P 1	L 25	# 1	C/ 116	SC 116.1.4	P 28	L 8	# 4
Hajduczenia, Marek	ر م Charter Comn		# I	Brown, Mat		F 20 Huawei	LO	# 4
		nunications	hualiat	,				
Comment Type E	Comment Status D	ow it will be 202	bucket	Comment 7	51	Comment Status D	ld ha hattar ta ar	aata a naw tabla far
	is no lomnger correct - we kn	low it will be 202	ZTelease			n the defined margins. It wou PHYs. Note that 400GBASE-		
SuggestedRemedy						ASE-Z as defined in 1.4.144		
Change all dated refere	ences to 802.3 from 202x to 2	022		Suggested	Remedy			
Proposed Response	Response Status W					16-5 to "PHY type and claus	e correlation (40	0GBASE-R optical)"
PROPOSED ACCEPT.						ial instruction and change for		
C/ 120A SC 120A.6	P 103	L 8	# 2			ation (400GBASE-Z optical)" 16-5 in D2.0 with only the ne		
	Charter Comn	-	# 2	Proposed R		Response Status W		
Hajduczenia, Marek		nunications		,

TYPE: TR/technical required ER/editorial required GR/general required T/technical E/editorial G/general COMMENT STATUS: D/dispatched A/accepted R/rejected RESPONSE STATUS: O/open W/written C/closed U/unsatisfied Z/withdrawn SORT ORDER: Comment ID

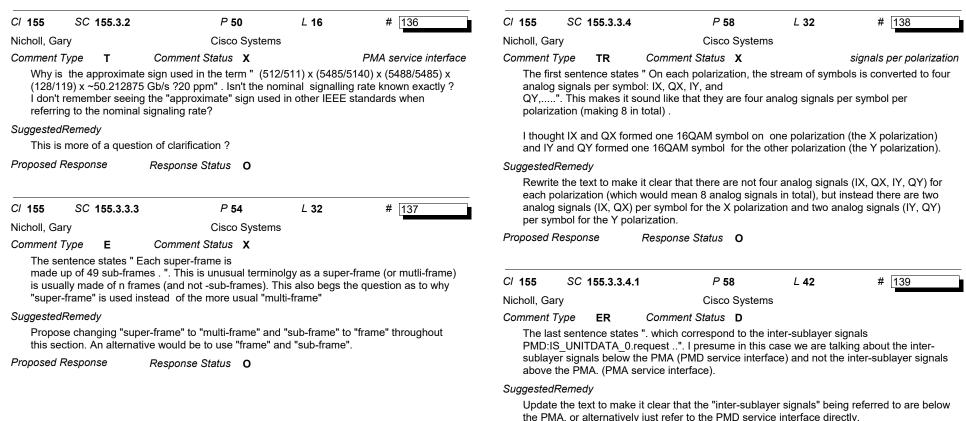
Comment	2	Comment Status D		PCS description	Proposed	Respon	se	Response Status W		
	51	from reading the descriptions a	is to how the 4000	BASE-ZR base	PROP	OSED A	ACCEPT.			
~		3), 400GBASE-ZR OH frame (Fi related and aligned ?	igure 155-4) and t	he SC-FEC frame	C/ 155	SC ·	155.3.1	P 49	L 3	# 135
	e 100-0) are i								- •	100
(Figure	,	-			Nicholl Ga	arv		Cisco Systems		
(Figure) S <i>uggested</i>	dRemedy	r diagram to indicate how the va	arious frame struct	tures described in the	Nicholl, Ga	,	ED	Cisco Systems		
(Figuro) S <i>uggested</i> Add a	dRemedy description o	or diagram to indicate how the va and aligned (if indeed they ar		tures described in the	Comment	Туре	ER	Comment Status X	eat the same	format as section
(Figure Suggested Add a comm Proposed	dRemedy description o ent are relate Response	ed and aligned (if indeed they ar <i>Response Status</i> W		tures described in the	Comment The fir 155.1.	<i>Type</i> st sever It appe	ral sub-sec ars that thi	Comment Status X tions of 155.3.1appear to repose s overview information for the	PCS sublay

(Figure Suggested Add a comm Proposed	dRemedy description o ent are relate Response	ed and aligned (if indeed they ar		tures described in the	Comment The fir 155.1 same	<i>Type</i> st sever It appea overviev	ral sub-sec ars that thi w informati	Comment Status X tions of 155.3.1appear to rep	PCS sublay	
(Figuro Suggestec Add a comm Proposed PROP	dRemedy description o nent are relate Response POSED ACCE	ed and aligned (if indeed they ar <i>Response Status</i> W	re aligned).		Comment The fir 155.1. same Suggested I would	<i>Type</i> st sever It appe overviev <i>Remed</i> d propos	ral sub-sec ars that thi w informati y se to delete	Comment Status X tions of 155.3.1appear to repose s overview information for the	PCS sublay 155.3. f the corresp	er is in 155.1 and the onding overview

Proposed Response Response Status W

PROPOSED ACCEPT IN PRINCIPLE.

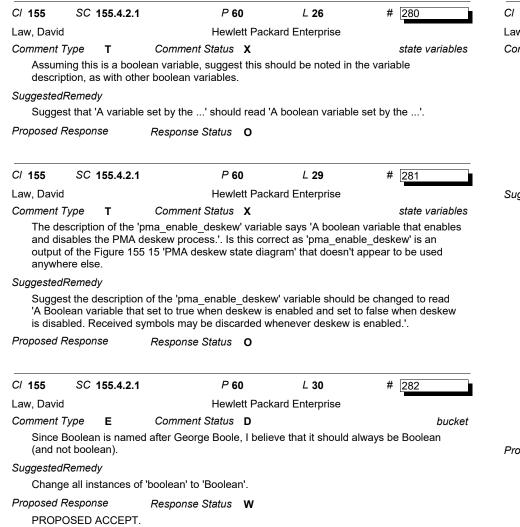
Comment Type E	Comment Statu	s X			Law, David		Hewlett Pack	ard Enterprise	
	to the line from P8, P4	and P3 where	re they connect	to the XOR logic	Comment T	ype E	Comment Status D		bucke
operator symbol.						t that ' frame n interpacket .	s with minimum interpacket '.	' should read '	frames with a
SuggestedRemedy See comment.					SuggestedF	•			
	Deserves Ofert	•			See cor				
Proposed Response	Response Status	s U			Proposed R	esponse	Response Status W

•	SED ACCEPT			
C/ 155 SC 155.3.	3.3.3 P	57	L 33	# 276					
Law, David	Hev	vlett Packard	Enterprise		C/ 155	SC 155.3.3.	7 P 59	L 42	# 279
Comment Type E	Comment Statu	s X			Law, David		Hewlett Pack	ard Enterprise	
	two separate tables nu				Comment T	ype E	Comment Status D		bucket
generator polynomia	al and seed values', th	e second labe	elled 'Table 155	5-6-PS'.			Receive signal processing' sa		
SuggestedRemedy							o (see 1.4.275) of less than 1. gap when additionally process		
tables renumbered,	second Table 155-6 'F and its title should be title of the second Tab			•		nat the addition	ally processed is in reference		
'Pilot sequence'.			ala be changed		SuggestedF	Remedy			
Proposed Response	Response Status	s O					additionally processed accord rding to this clause.'.	ling to this clause	e.' should read '
					Proposed R

PROPOSED ACCEPT.

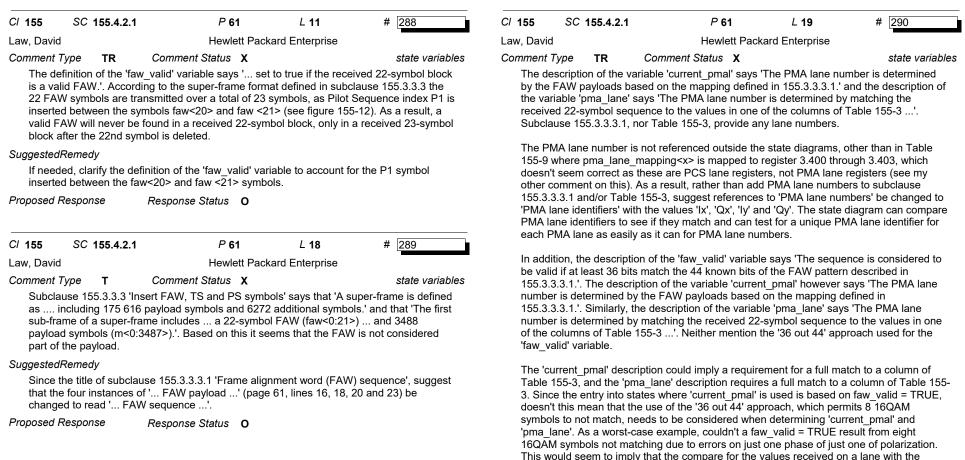
Comment	Туре	т	Comment Status	(state variables	Comment 7	уре	TR	Comment Stat	us X		state variables
frame lanes. restart Figure 155-16 Suggested [1] Rei	alignme It is set Lock vi 155-14 3. IRemed name a	ent word (f to TRUE ariable is u l, it is also ly ll instance	when 15 FAWs in a ro	eset the synchronizati w fail to match (15_B/ ment word (FAW) locl marker lock process ariable used in Figure	on process on all PMA AD state).'. While the c process described in described in Figure	listed ir match t listed ir interfac 'faw_va <https: <br="">referen bits ma</https:>	n Table the 44 n Table e, are alid ana //www.i cing a tching	155-3.' bu known bits 155-3, an both 22 Dl alysis' from ieee802.or 'QPSK FA the 44 kno	ut then 'The sequ s of the FAW patt ad the candidate s P-16QAM symbo n Mike Sluyski rg/3/cw/public/22 W' value of 44 in own bits should b	ence is co ern descri sequences ls, not 44 _0523/slu the sprea e to 36 16	onsidered to be va ibed in 155.3.3.3. s received over th bits. Based on sli yski_3cw_01a_22 adsheet, I assume 6QAM symbols ma	de 4 of the contribution 20523.pdf#page=4> the reference to 36 atching the 44 16QAM

[2] Rename all instances of the 'restart_lock' variable used in Figure 155-16 'Alignment marker lock state diagram' to be 'pcs_restart_lock'. [3] Rename 'restart lock' variable in subclause 155.4.2.1 'Variables' to be 					symbols (which form the 22 DP-16QAM symbol FAW sequence), defined in Table 155-3. Additionally, isn't it the case that the four components of the DP-16QAM symbols of the candidate 22 symbol block received over the four-lane PMD service interface can be mapped to the four lanes in any of eight ways defined in Table 155-7? If that is the case,							
	restart_			a 155.4.2.1 Vallables	to be	suggest that this is also addressed in the description of the 'faw_valid' variable. SuggestedRemedy						d' variable.
[4] Ado	d a defiı	nition of th	e 'pcs_restart_lock' va	riable to subclause 15	5.4.2.1 'Variables'.	Suggest that the 'faw_valid' variable description should be changed to read:						to read:

Proposed Response Response Status O						over the 16QAN conside The ca least 36	e four-l 1 symb ering al ndidate 6 of its	lane PMD ol block is Il permitted 22 DP-16 componer	service interface compared to the d PMD service int 6QAM symbol blo nt 16QAM symbo	is a valid FAW seq erface lar ck is cons ls match,	FAW sequence. Tuence defined in nes mappings defined to be a va	ined in Table 155-7. lid FAW sequence if at e position, and the 44
						Proposed F	Respon	se	Response Statu	is O
